Subject: Revised Request for Modification of the Phased Section 404 Individual Permit and Section 401 Individual Water Quality Certification for the construction of the Triangle Expressway Southeast Extension from NC-55 Bypass in Apex to I-40, Wake and Johnston Counties. TIP Nos. R-2721, R-2828, and R-2829. Federal Aid Project No. 0540047.

We are requesting a modification to the Section 404 Authorization (SAW-2019-02240) and the associated 401 Water Quality Certification (Permit No. 20181249). This request arises from design

modifications to the bridge end bent over Bushy Branch. Adjustments to the bridge design have resulted in revisions to the approved plans, which in turn have altered the proposed impacts to jurisdictional resources.

PROJECT REFERENCE NO.	SHEET NO.
7-28224	7
RW SHEET NO.	
REVISED 5/9/2025 REVISED 8/1/2025	
DOCUMENT NOT CONSIDERED FINAL UNLESS ALL SIGNATURES COMPLETED	
PERMIT DRAWING SHEET 11 OF 103

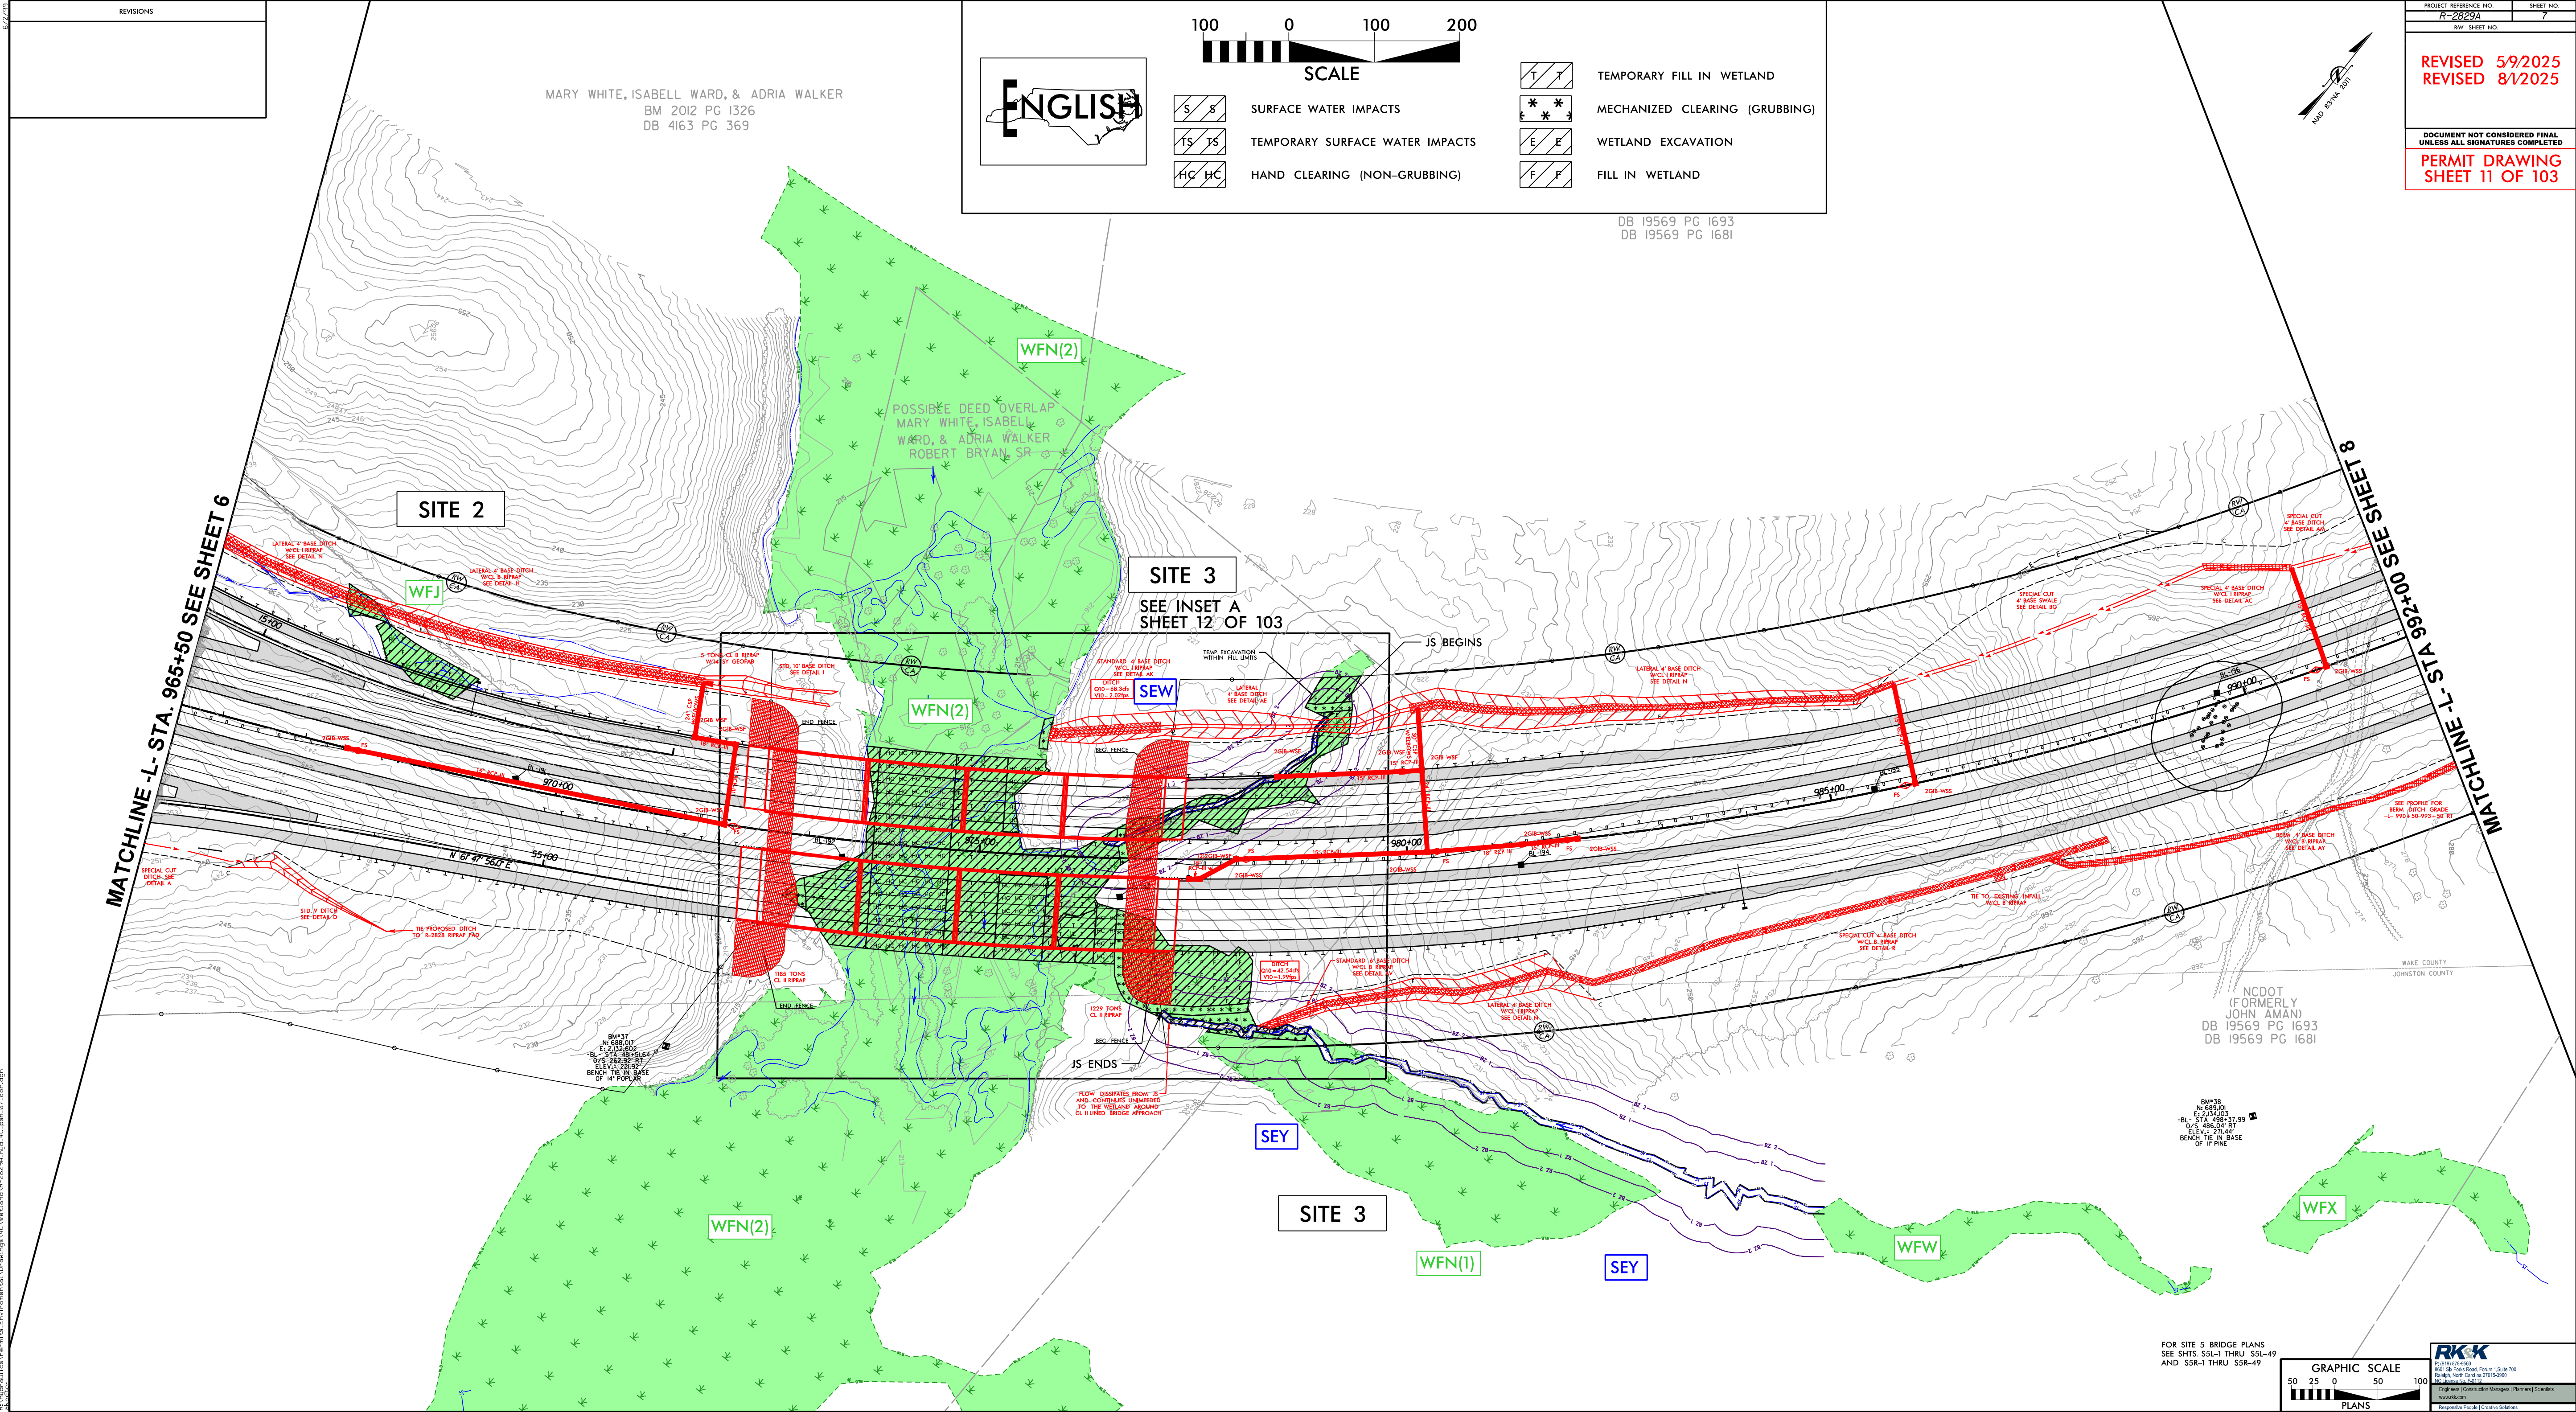
- Permanent wetland fill: 0.184 ac (previously 0.176 ac)
- Temporary wetland fill: 0.706 ac (previously 0.716 ac)
- Mechanized clearing in wetlands: 0.037 ac (previously 0.034 ac)

A low contour area was identified within wetland WFN(2), adjacent to the bridge end bents over Bushy Branch. To address this condition, the end bent slopes were regraded to a 1.5:1 slope, extending beyond the original mechanized clearing and permanent fill limits. This modification converts temporary wetland impacts to permanent wetland impacts. No additional impacts to streams or riparian buffers will occur at this location.

Site 3: 4 interior bents with 4 @ 3.5' diameter columns per bent= total 154.4sq ft (0.004ac) permanent wetland impact (included above)

Temporary Excavation (~0.01ac) within the permanently impacted wetland footprint limits due to an erosion control clean water diversion channel
